UNIT 1 IMPROVED TECHNICAL SPECIFICATIONS

1.1 Definitions

Figure 3.6-1 Pressure versus Minimum Temperature for Pressure Tests, Based on Surveillance Test Results

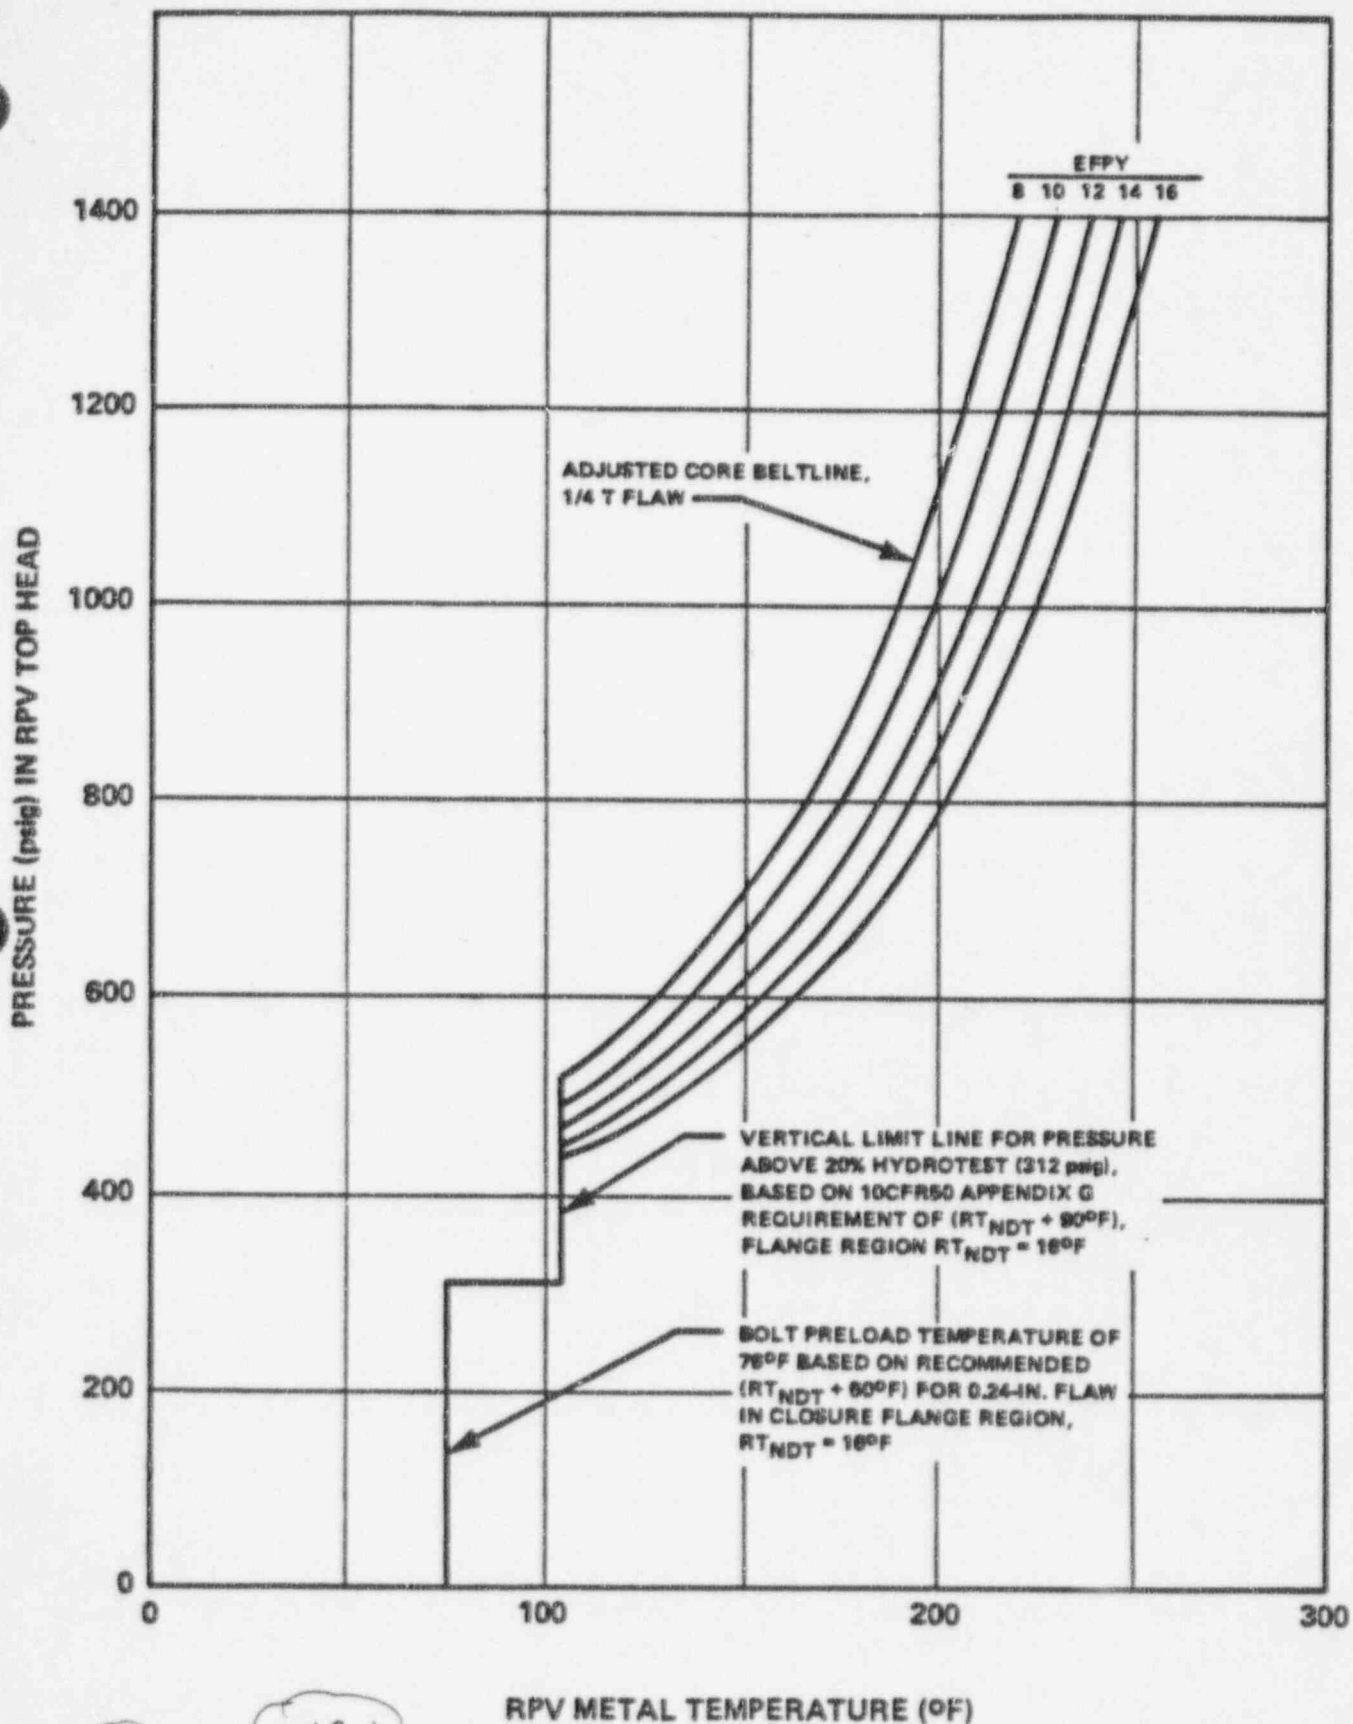
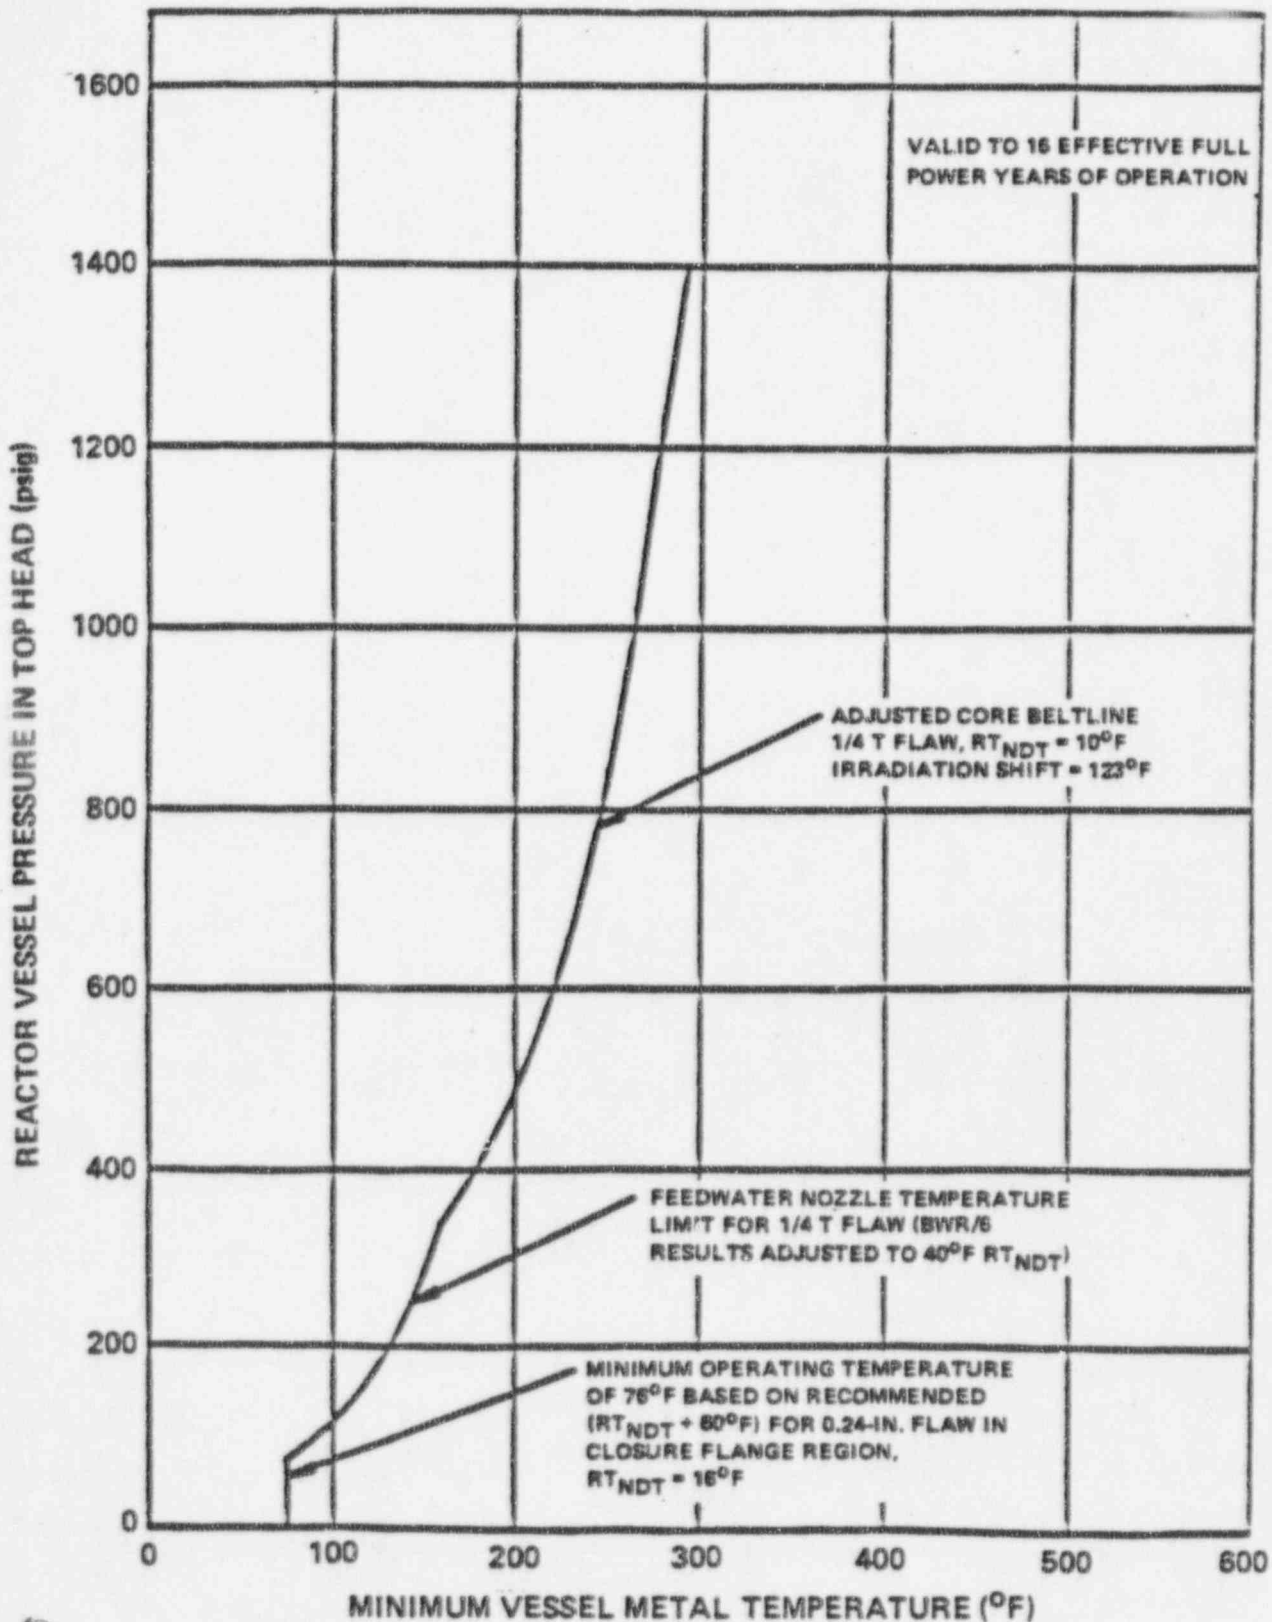
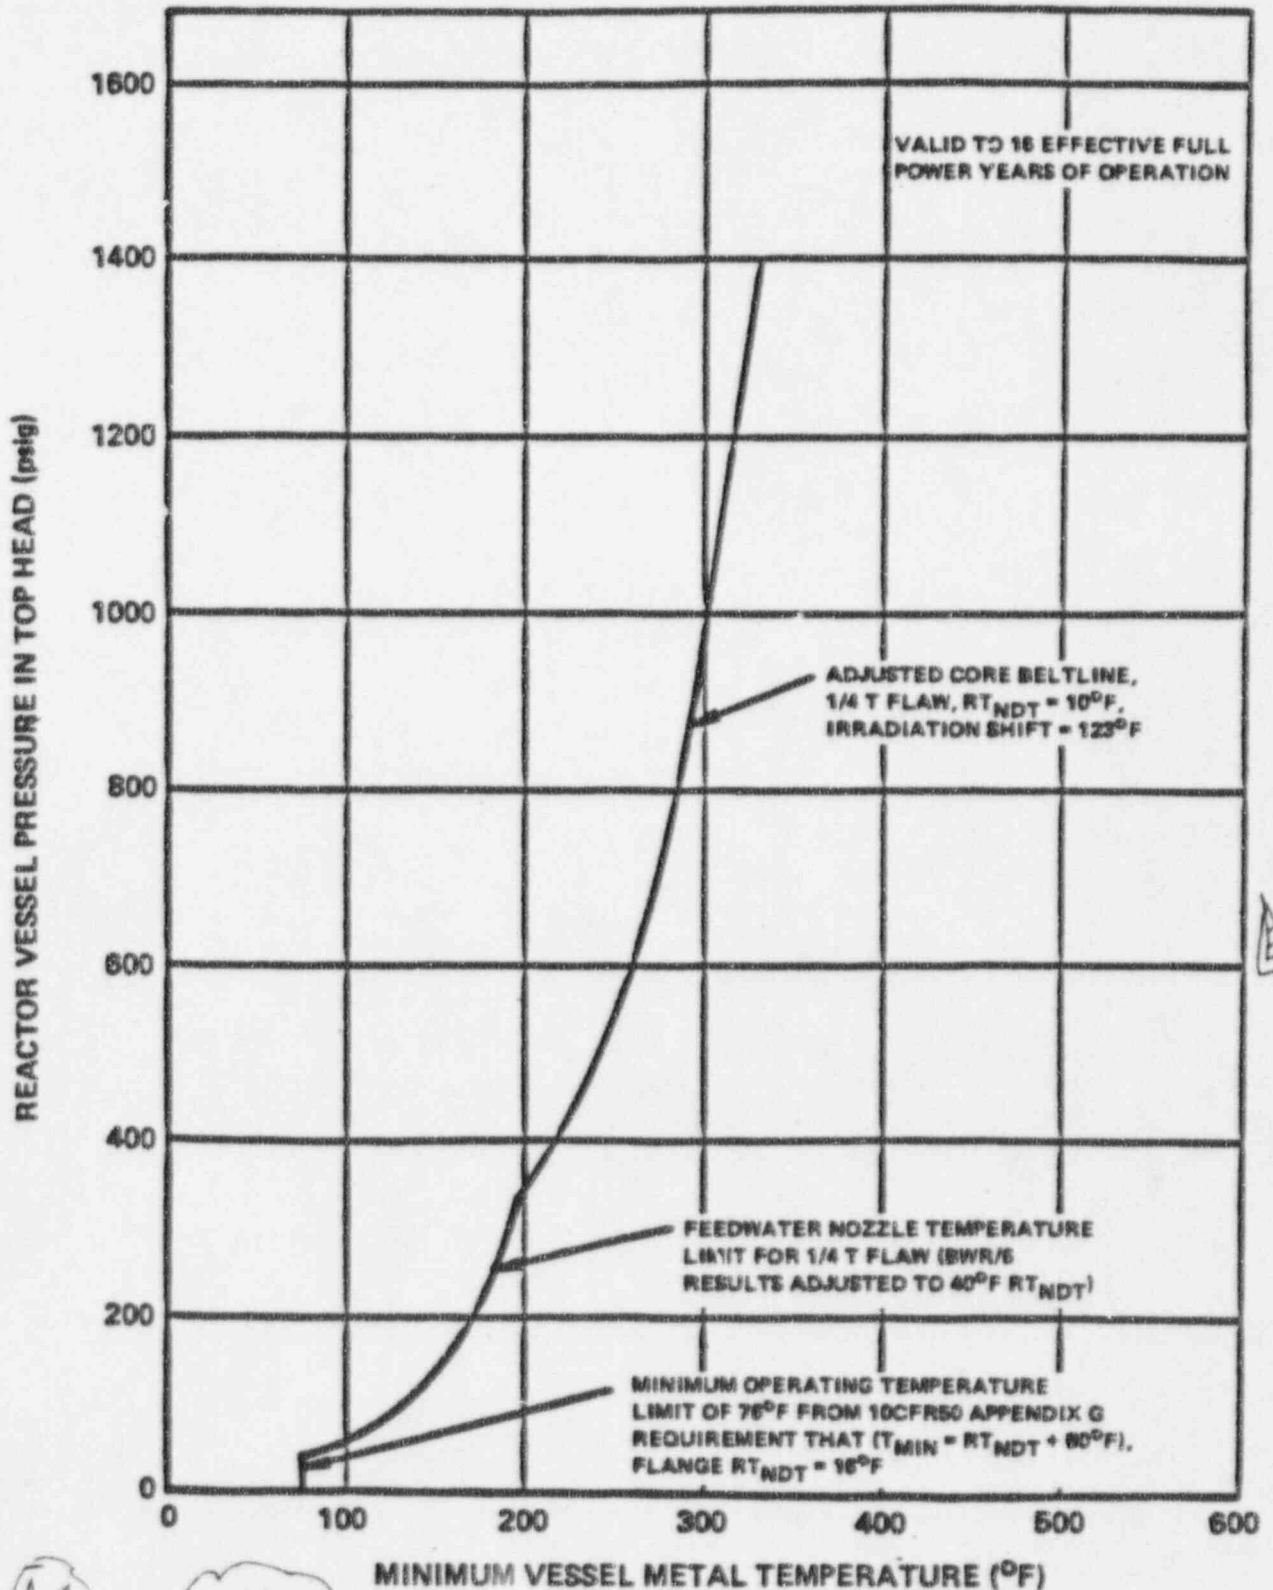
- A.1 Reformatting and renumbering requirements are in accordance with the BWR Standard Technical Specifications, NUREG 1433. As a result, the Technical Specifications should be readily readable, and therefore, understandable by plant operators as well as other users. During this reformatting and renumbering process, no technical changes are to the Technical Specifications have been made unless there are identified and justified. In the specific case of the Primary System Boundary Section the new section number is 3.4, which has been titled "Reactor Coolant System (RCS)."

- M.3 ACTIONS have been added (proposed ACTIONS A, B, and C) to provide direction when the LCO is not met. Currently, no ACTIONS are provided. Proposed ACTIONS are consistent with the BWR Standard Technical Specifications, NUREG 1433, and are additional restrictions on plant operation.

A.4 Figure 3.4.9-2. ~~Pressure versus Minimum Temperature for Non-Nuclear Heatup/Cool-down and Low Power Physics Tests~~
 3.4.9-2 Temperature - Pressure Limits for Non-Nuclear Heatup,
 Low Power Physics Tests and Cool-down Following
 A shutdown

Figure 3.4.9-3: Temperature-Pressure Limits for Criticality Pressure versus Minimum Temperature for Core Critical Operation other than Low Power Physics Tests (includes 40°F Margin Required by 10CFR50 Appendix G)

FIGURE 3.4.9-2

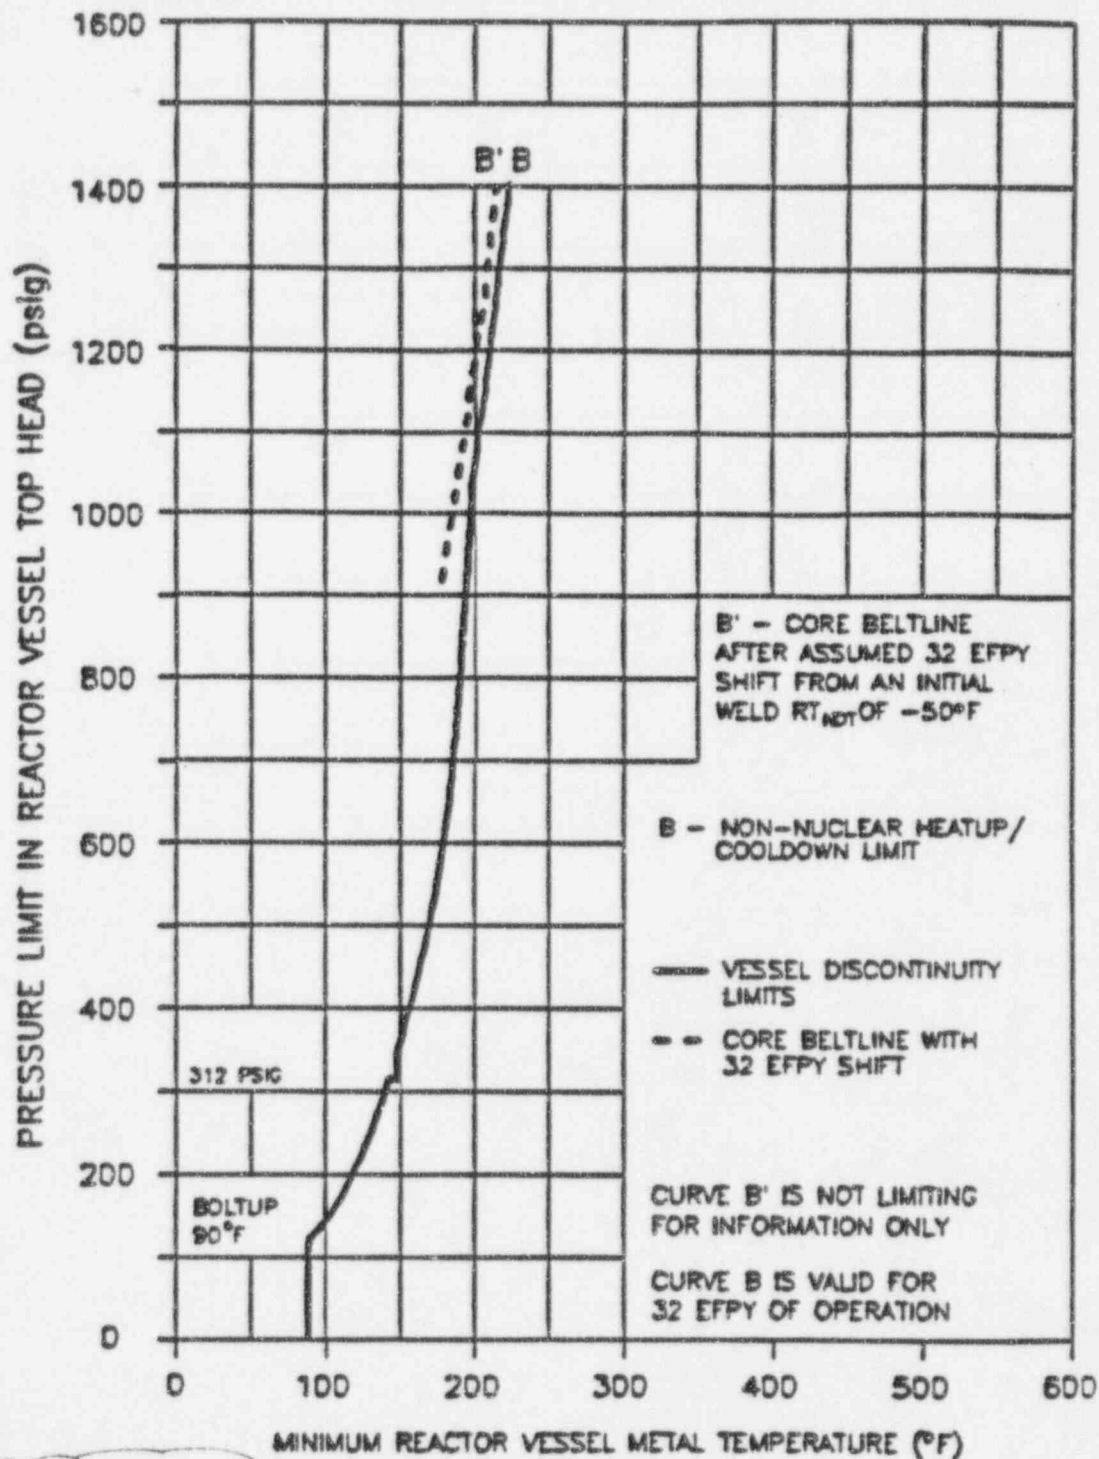
TEMPERATURE PRESSURE LIMITS FOR NON-NUCLEAR HEATUP, LOW POWER PHYSICS TESTS AND COOLDOWN FOLLOWING A SHUTDOWN

FIGURE 3.4.9-3

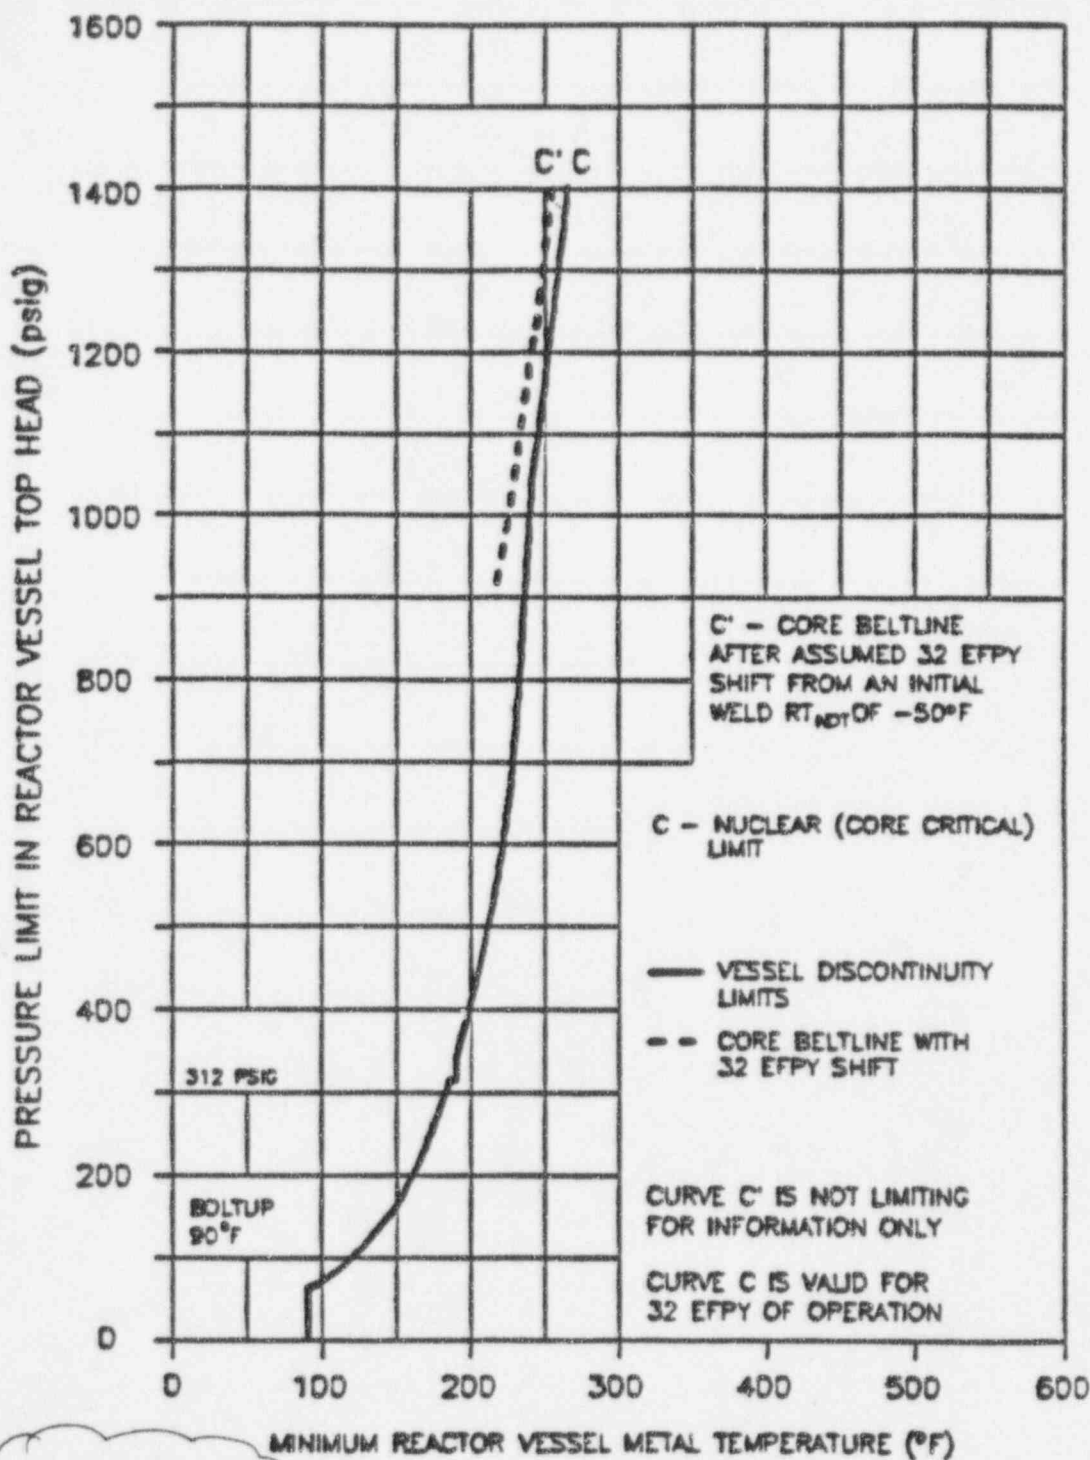
TEMPERATURE-PRESSURE LIMITS FOR CRITICALITY
 (INCLUDES ADDITIONAL 40°F MARGIN
 REQ'D BY 10CFR50, APP-G)
 FIGURE 3.4.6.T-2
